**BOARD OF ZONING ADJUSTMENT
STAFF REPORT****Date: October 2, 2017****CASE NUMBER**

6132 / 5827

LOCATION5706 U.S. Highway 90 West
(West side of U.S. Highway 90 West, 55'± South of
Plantation Road.)**VARIANCE REQUEST****ACCESS AND PARKING SURFACE:** Access and
Parking Surface Variances to allow gravel access and
parking for a business in a B-3, Community Business
District.**ZONING ORDINANCE
REQUIREMENT****ACCESS AND PARKING SURFACE:** The Zoning
Ordinance requires access and parking areas to be paved
with asphalt, concrete or an approved alternative paving
surface in a B-3, Community Business District.**ZONING**

SITE PLAN

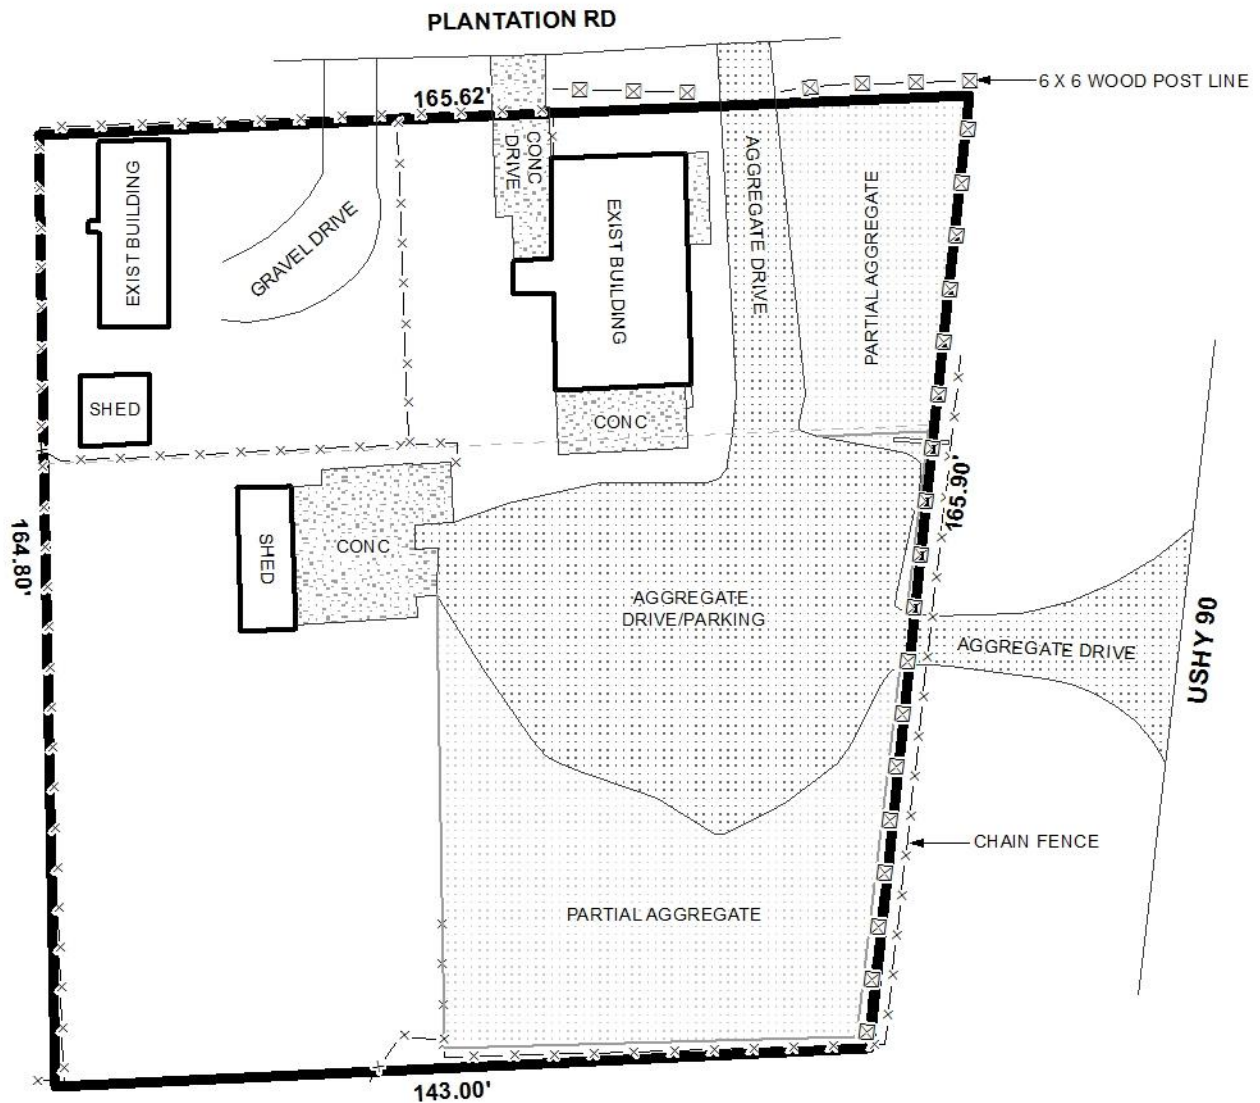
A survey of the site was provided by the applicant as a site plan and does not appear to differ from the previous site plan; and thus does not appear to depict prior conditions of approval. Undated photographs provided by the applicant do show wheel stops where customer parking would be located, as well as wooden posts to contain automobile inventory, but it is not clear if the site meets compliance with off-street parking requirements. As such, revision of the site plan should be required to illustrate compliance with off-street parking for customers of automobile sales businesses, the ratio of which is one (1) space per three hundred (300) square-feet of office space; and, if applicable, one (1) space per three (3) warehouse employees.

It should be noted that Engineering typically requires access to and from handicapped parking spaces, as well as the spaces themselves, be paved in either asphalt or concrete. While this was not mandatory for previous Variance approvals for the site, the applicant should provide paved, handicap-accessible parking, which should comply with International Building Code (IBC) and Americans with Disabilities Act (ADA) standards, and should be illustrated on a revised site plan.

The undated photographs provided by the applicant appear to be from several years ago as they do not reflect recent Google Street View images from November, 2016. The Google images depict chain link and wood privacy fencing around what would presumably be the lot on which automobile inventory would be stored, and no wheel stops are visible. If the Google images reflect existing site conditions, then the site plan should be revised and after-the-fact permits for the fencing will be required.

A dumpster is not depicted on the site plan. If a dumpster is placed on the property, it must be in compliance with the current enclosure and sanitary sewer connection requirements of Section 64-4.D.9. of the Zoning Ordinance and must be illustrated on any revised site plan(s); or, a note should be placed on the site plan stating that curbside pickup will be utilized.

- 1) revision of the site plan to illustrate wheel stops in compliance with Section 64-6.A.6. of the Zoning Ordinance regarding required amounts of off-street parking;
